DETAILED ACTION

Continued Examination Under 37 CFR 1.114

**Fig. 1**

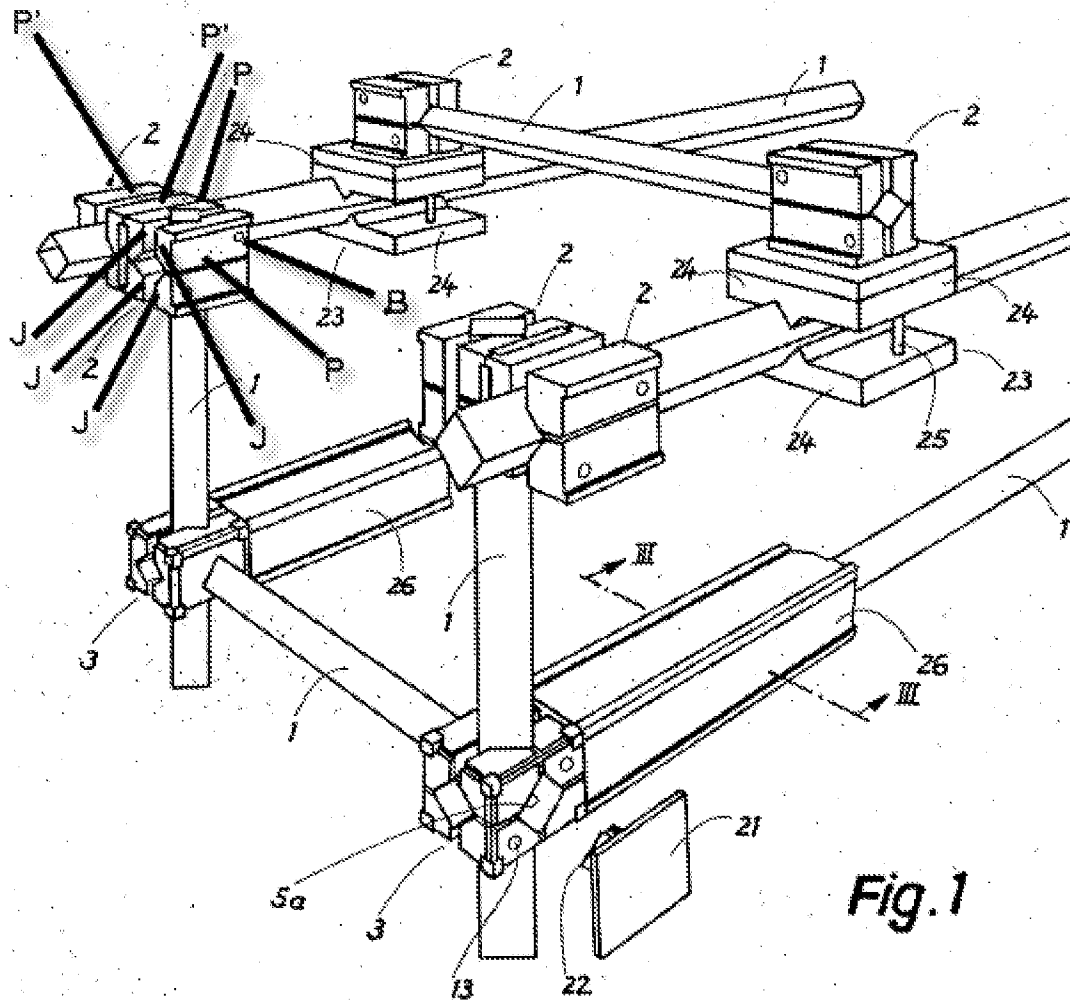
Claims 1 and 3 are rejected under 35 U.S.C. 102(b) as being anticipated by Patent DE 3736266 A1 Neff et al.

With respect to claim 1, Neff et al. disclose a system (Fig. 1) for detachable joining of at least first and second beams (1) of rectangular cross-section comprising for each said first beam (1) to be joined, a first pair of fixing plates (P) mountable on opposite sides of a said first beam (1) and fixable along said first beam by friction maintained by tightening bolts (B), each one of the fixing plates (P) comprising an inner surface adapted to face said first beam (1), and outer surface, which is adapted to face away from said first beam (1), for said second beam (1) to be joined, a second pair of fixing plates (P') mountable on opposite sides of said second beam (1) and fixable along said second beam by friction maintained by tightening bolts, each one of the fixing plates (P') comprising an inner surface adapted to face said second beam (1), and an outer surface, which is adapted to face away from said second beam (1), the outer surface of said first pair of fixing plates (P) being bearable against the outer surface of said second pair of fixing plates (P') when said first and second beams are arranged to be joined in perpendicular or parallel directions the relative positions of said first and second pairs of fixing plates (P, P') being fixed by locking elements (constituted by nuts not shown) in recesses in said outer surfaces of the said first and second fixing plates (P, P') said locking elements also anchoring the

tightening bolts (B).

With respect to claim 3, Neff et al. disclose (Fig. 1) that the each fixing plate (P, P') comprises projections (J) arranged at each corners of the fixing plate (P, P').
